### CAPITAL TRANSIT VALLEY TRANSFER STATION Contract No. BE20-268

**ADDENDUM NO.:** TWO

**DATE ADDENDUM ISSUED:** May 28, 2021

Item No. 1 SHEET E-302 POLE AND HANDHOLE DETAILS

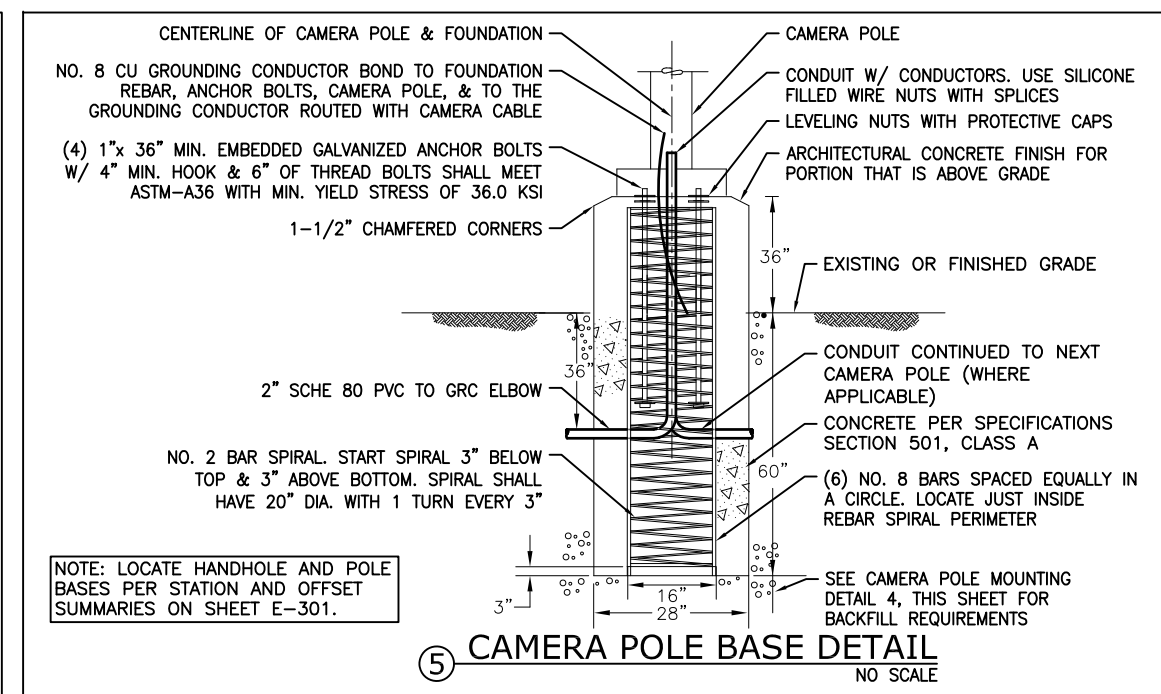
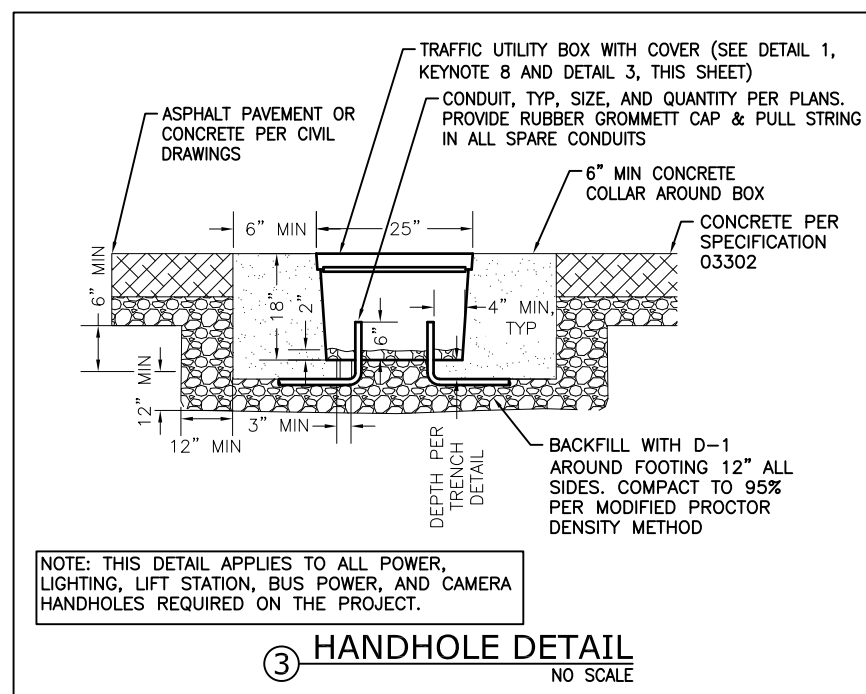
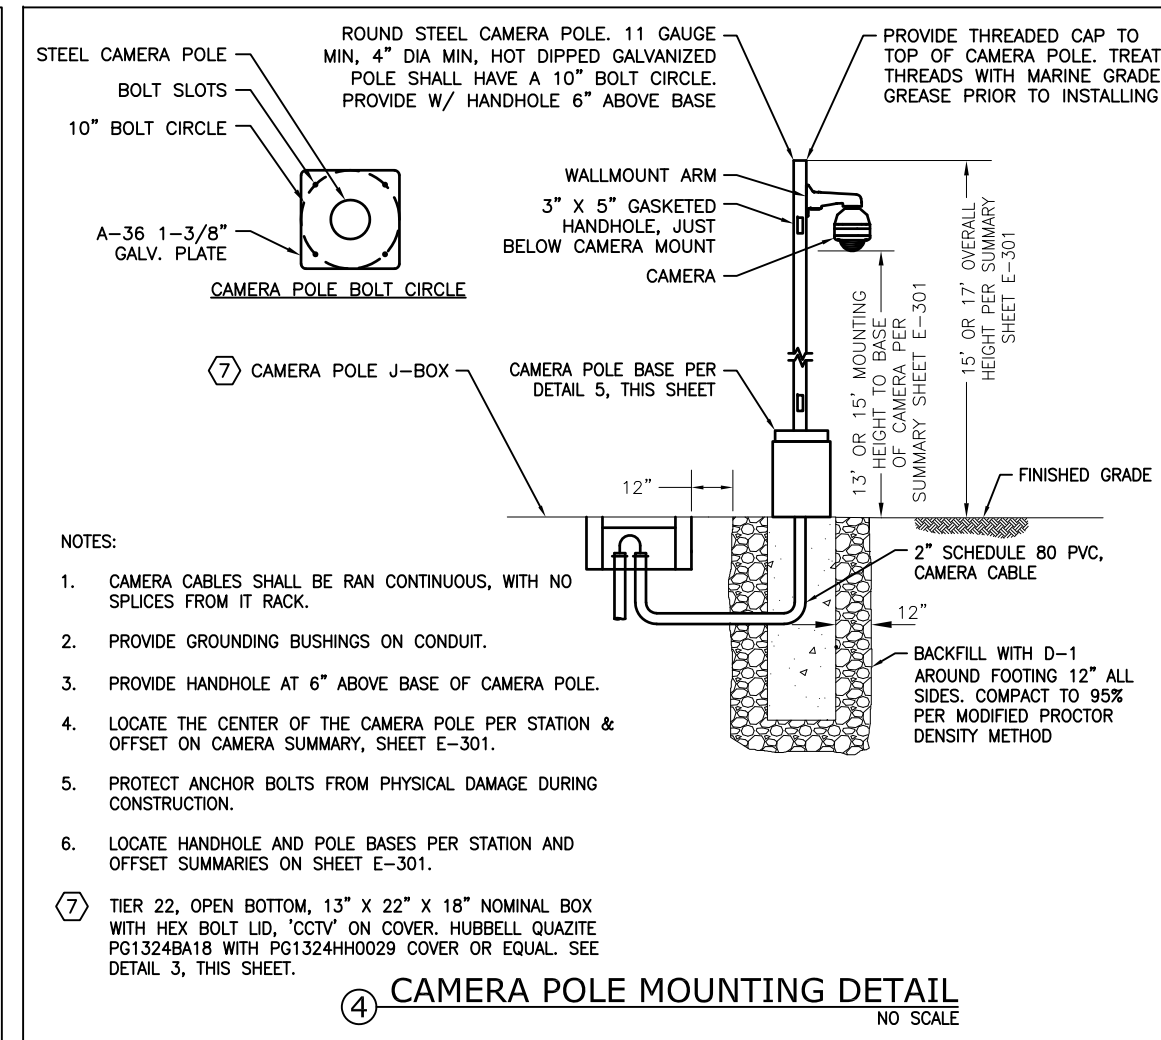
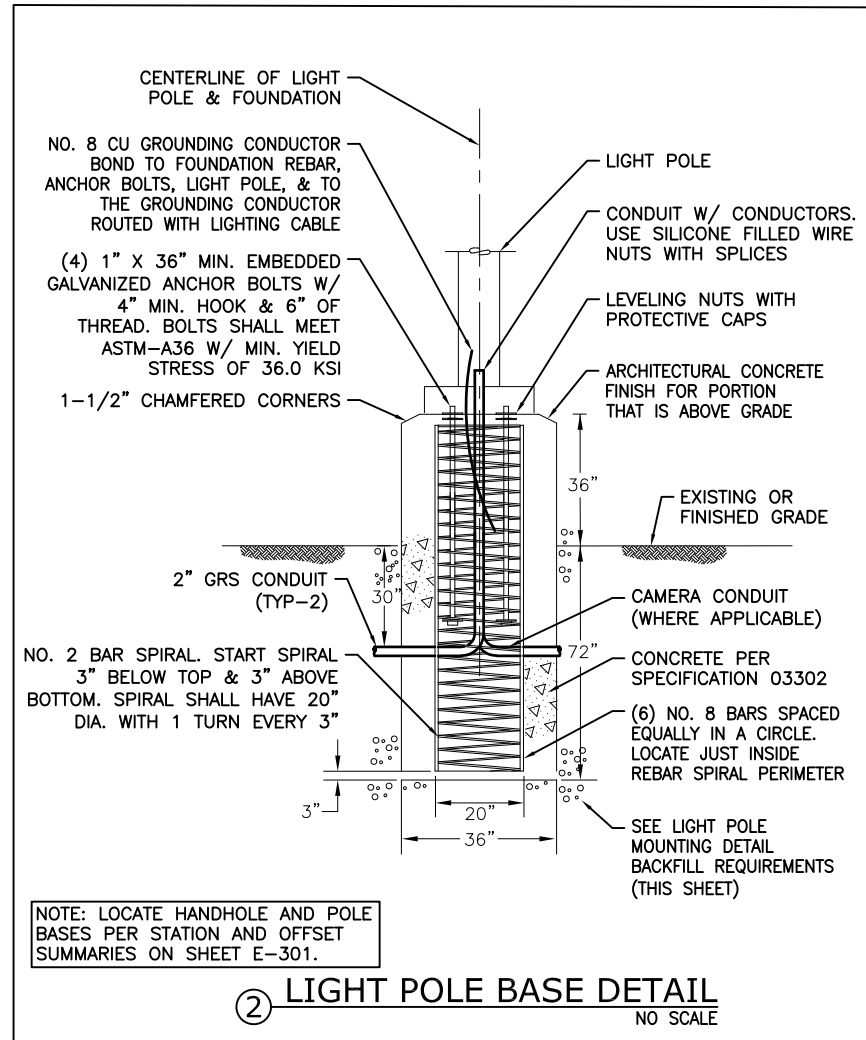
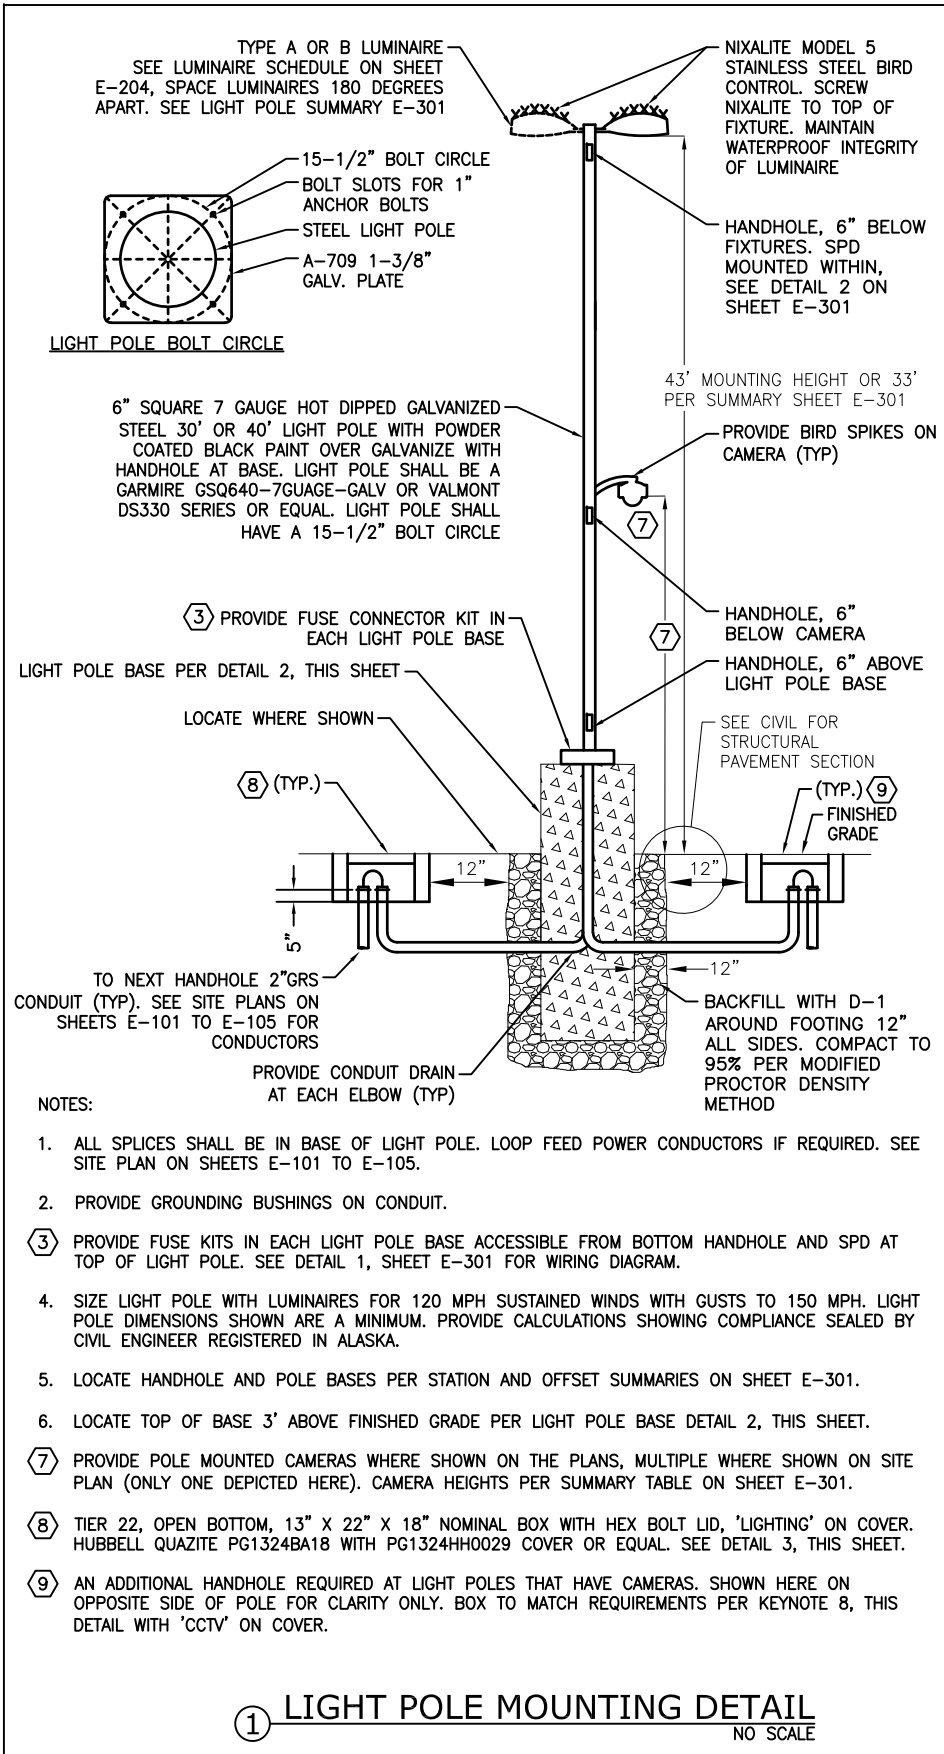
**Delete** SHEET E-302 and **replace with** the attached SHEET E-302 labeled Addendum No. 2, which replaces 96" with 72" regarding light pole base bury depth within the "2 – Light Pole Base Detail" plan area, but retains the 36" of exposed finished base above ground.
